Remarks

Page 10
Serial No. 09/868,122
May 16, 2003

WO 00/35271

PCT/NL99/00775

Fig. 2

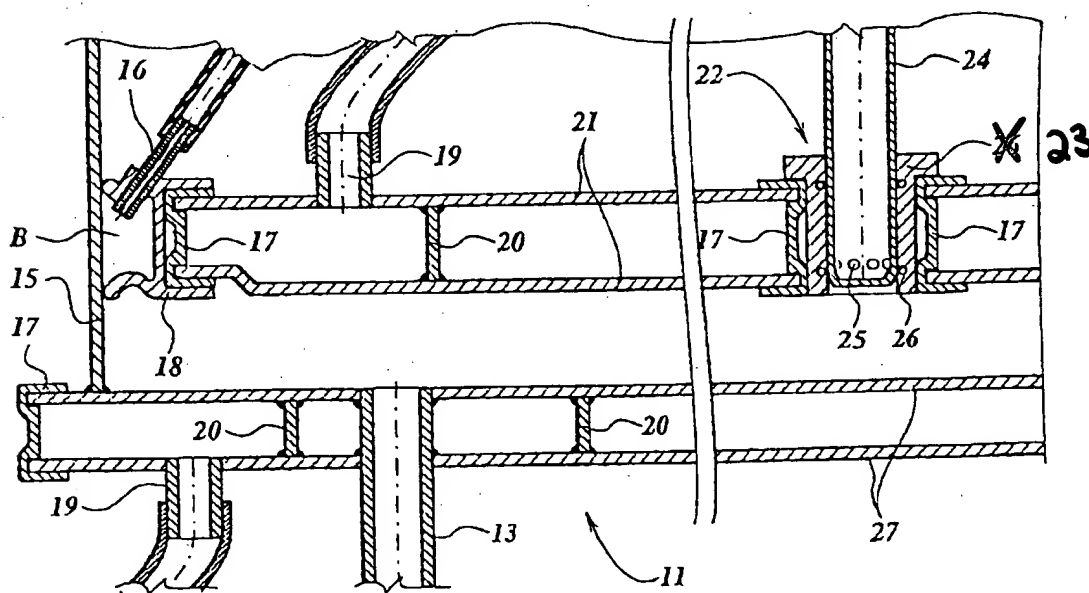
The Examiner has objected to the drawings for failure to comply with 37 C.F.R. 1.84(p)(5) because reference sign 23 was not included in the drawings. Fig. 2 has been amended to include sign 23, thus overcoming the Examiner's objection.
